PD $I_{Port_RMS_max}$ requirement

Lennart Yseboodt, Matthias Wendt

Philips Lighting – Research

March 7, 2017

145.3.8.2 on Input average power says the following:

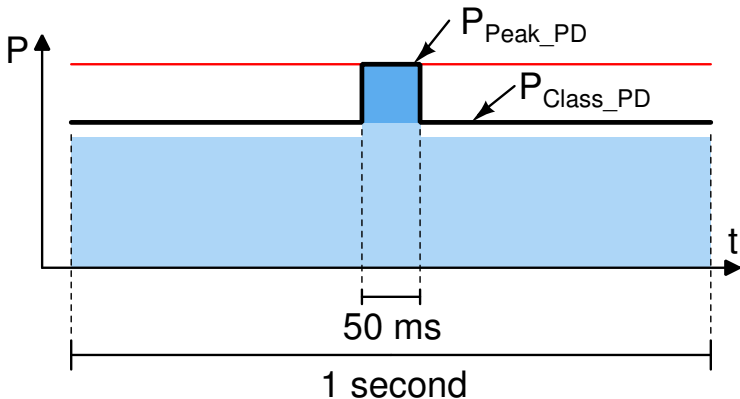
$P_{\text{Class_PD}}$ is the maximum average PI power and applies to single-signature PDs. The maximum average power, $P_{\text{Class_PD}}$ or $P_{\text{Class_PD-2P}}$ in Table 145-24, Table 145-25 and Table 145-28 or PDMaxPowerValue in 145.5.3.3, is calculated over a 1 second interval.

NOTE - Average power is calculated using any sliding window with a width of 1 s.

Average power is defined as the product of the RMS current and voltage.

- 1: Absolute max power consumption is P_{Peak_PD} .
- 2: Total blue area of a sliding window of 1 second must be $< P_{Class_PD}$
- 3: The $I_{Port_RMS_max}$ requirement is a repeat of (2) expressed in current.
